**Your ref: EN010092**

### Thurrock Flexible Generation Plant – Deadline 7 Letter

This letter accompanies documents submitted by Thurrock Power Ltd to the Planning Inspectorate at Deadline 7. The following information requested for Deadline 7 in the Rule 8 letter (09 June 2021) and Rule 17 letter (29 July 2021) has been submitted.

**Order Limits correction (previous: dotted red line; corrected: solid red line)**

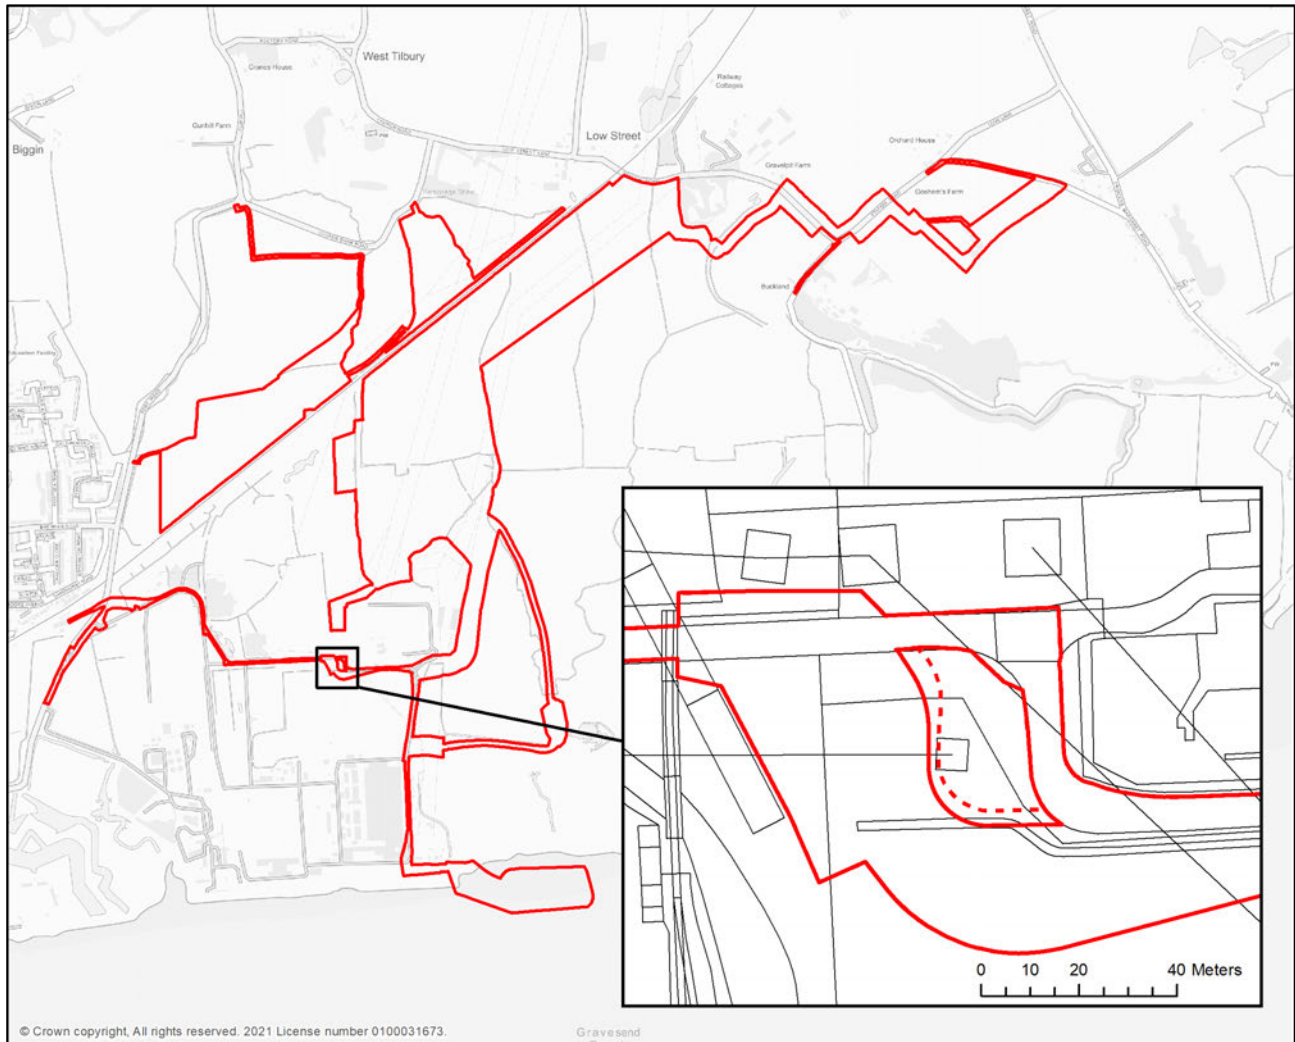
<p>An unsigned, proposed final draft SoCG with the Marine Management Organisation (MMO) is enclosed as the Applicant has not received a response from the MMO.</p> <p>No SoCG with RWE or PoTLL is available. The parties have been focused on negotiations for the access agreement and agreeing, in so far as is possible, the wording of protective provisions.</p>
Final Compulsory Acquisition Schedule in clean and tracked versions	Enclosed.
Final Guide to the Application	Enclosed.
A final schedule of changes to the dDCO	Enclosed.
Final dDCO to be submitted by the Applicant in the Statutory Instrument (SI) template with the SI template validation report	<p>Enclosed.</p> <p>(The stationery office is experiencing technical issues which have delayed the issue of the validation report. The validation report will follow as soon as it is available.)</p>
Resubmission of final version of updated application documents	<p>The following final versions of updated documents are enclosed:</p> <ul style="list-style-type: none"> <li>• A2.1 Location and Order Limit Plans</li> <li>• A2.2 Land, Special Category Land and Crown Land Plans</li> <li>• A2.3 Works Plans</li> <li>• A2.4 Access, Rights of Way and Traffic Regulation Measures Plans</li> <li>• A2.5 Illustrative Highway Engineering Drawings</li> <li>• A2.6 Illustrative General Arrangement Plans</li> <li>• A2.7 Illustrative Landscape Plan</li> <li>• A2.11 Historic or Scheduled Monument Sites Plan</li> <li>• A2.12 Statutory and Non-Statutory Nature Conservation Sites</li> <li>• A2.13 Tree Preservation Order and Hedgerow Plan</li> <li>• A3.1 Draft Development Consent Order</li> <li>• A4.3 Book of Reference</li> <li>• A5.2 Habitats Regulations Assessment Report</li> <li>• A6.2.2 Chapter 2 – Project Description</li> <li>• A7.7 Other Consents and Licences Statement</li> <li>• A8.6 Code of Construction Practice</li> <li>• A8.7 Outline Ecological Management Plan</li> </ul> <p>Final versions of all other documents, submitted at previous deadlines, are as identified in the final Guide to the Application.</p> <p>A minor drawing error on the DCO plans has been corrected, where the Order Limits have been reduced by around 2m to avoid conflict with a pylon base near Tilbury Substation. The location of this correction is illustrated below.</p>
